Access Compliance Report

Public Rights-of-Way

Intersection ID: 44446	Main Street: REAMES_RD	Cross Street: PRESTBURY_BV	Location: SW
ADA ID: 84AEF0A58E78	Ramp Type: PerpDiag	Initial Pass/Fail: Fail	Overall Compliance: No
		Severity Score: 12.5

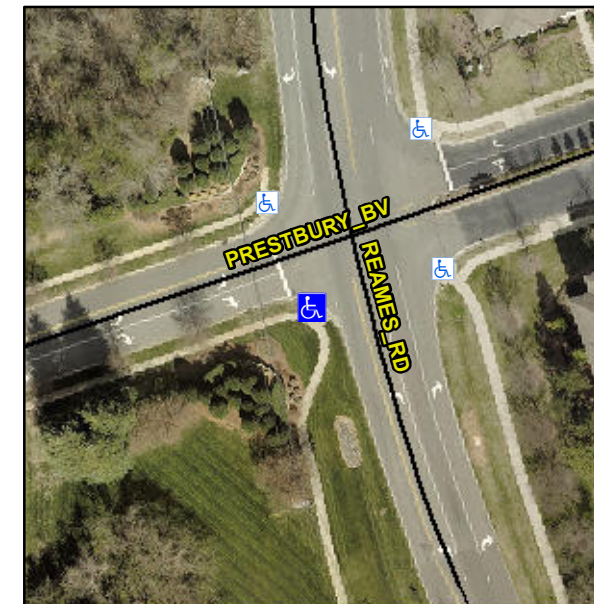
Not Found, R304.5.3

Compliance	Description	Data	Compliance	Description	Data
N/A	Ramp Length (in)	60.0	Yes	Ramp Slope (%)	6.5
Yes	Ramp Width (in)	53.0	No	Ramp XSlope (%)	5.4
N/A	Flare Type LT	N/A	N/A	Flare Type RT	N/A
N/A	Flare Slope LT (%)	N/A	N/A	Flare Slope RT (%)	N/A
N/A	Flare Traversable LT?	N/A	N/A	Flare Traversable RT?	N/A
N/A	Landing Length (in)	N/A	N/A	DWS Provided?	N/A
N/A	Landing Width (in)	N/A	N/A	DWS Contrast?	N/A
N/A	Landing Slope (%)	N/A	N/A	DWS Length (in)	N/A
N/A	Landing X Slope (%)	N/A	N/A	DWS Full Width?	N/A
N/A	Landing Curb? (Y/N)	N/A	N/A	DWS Offset (in)	N/A
N/A	Shared Landing?	N/A			
N/A	Gutter Ponding?	N/A	N/A	Gutter Slope (%)	N/A
N/A	Gutter Lip Ht (in)	N/A	N/A	Gutter X Slope (%)	N/A
N/A	Painted X Walk1?	No	N/A	Painted X Walk2?	No
	X Walk 1 Direction	To E		X Walk 2 Direction	To N
N/A	X Walk 1 Width (in)	N/A	N/A	X Walk 2 Width (in)	N/A
	X Walk 1 Slope (%)	3.2		X Walk 2 Slope (%)	2.8
	X Walk 1 X Slope (%)	1.2		X Walk 2 X Slope (%)	3.2

Remove & Replace Curb Ramp With Two New Directional Ramps or Equivalent.
